APPLICATION NO.	FILING DATE	FIRST NAMED INVENTOR	ATTORNEY DOCKET NO.	CONFIRMATION NO.	
10/822,064	04/08/2004	Neal Meyer	200312670-1	2065	
22879 7590 0223/2099 HEWLETT PACKARD COMPANY P O BOX 272400, 3404 E. HARMONY ROAD INTELLECTUAL PROPERTY ADMINISTRATION FORT COLLINS, CO 80527-2400			EXAM	EXAMINER	
			CHANG, RICK KILTAE		
			ART UNIT	PAPER NUMBER	
			3726		
			NOTIFICATION DATE	DELIVERY MODE	
			02/23/2009	ELECTRONIC

# Application No. Applicant(s) 10/822.064 MEYER ET AL. Office Action Summary Examiner Art Unit Rick K. Chang 3726 -- The MAILING DATE of this communication appears on the cover sheet with the correspondence address --Period for Reply A SHORTENED STATUTORY PERIOD FOR REPLY IS SET TO EXPIRE 3 MONTH(S) OR THIRTY (30) DAYS. WHICHEVER IS LONGER, FROM THE MAILING DATE OF THIS COMMUNICATION. Extensions of time may be available under the provisions of 37 CFR 1.136(a). In no event, however, may a reply be timely filed after SIX (6) MONTHS from the mailing date of this communication. If NO period for reply is specified above, the maximum statutory period will apply and will expire SIX (6) MONTHS from the mailing date of this communication - Failure to reply within the set or

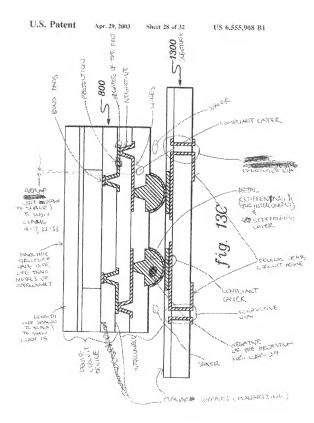
3. Claims 1-7 and 15-17 are rejected under 35 U.S.C. 102(e) as being anticipated by

Eichelberger et al (US 6,555,908).

Eichelberger discloses as follows:

The dielectric material of the interconnect forms a negative and receives and at least partially surrounds the projection as annotated above.

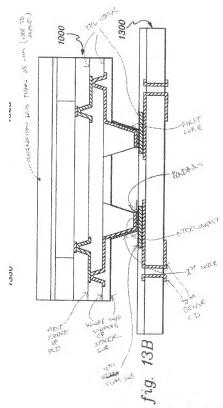
Claims 44-48 are rejected under 35 U.S.C. 103(a) as being unpatentable over Eichelberger et al (US 6,555,908) in view of Tong et al (US 6,962,835).

Eichelberger discloses as follows:

Eichelberger fails to discloses covalent bonding at LT.

Tong discloses covalent bonding at LT (metal-to-metal bonding (metals have loose electron outer valence shell) at RT; col. 9, lines 60-62).

It would have been obvious to one of ordinary skill in the art at the time the invention was made to modify Eichelberger by covalent bonding at LT, as taught by Tong, for the purpose of eliminating solder between metals.
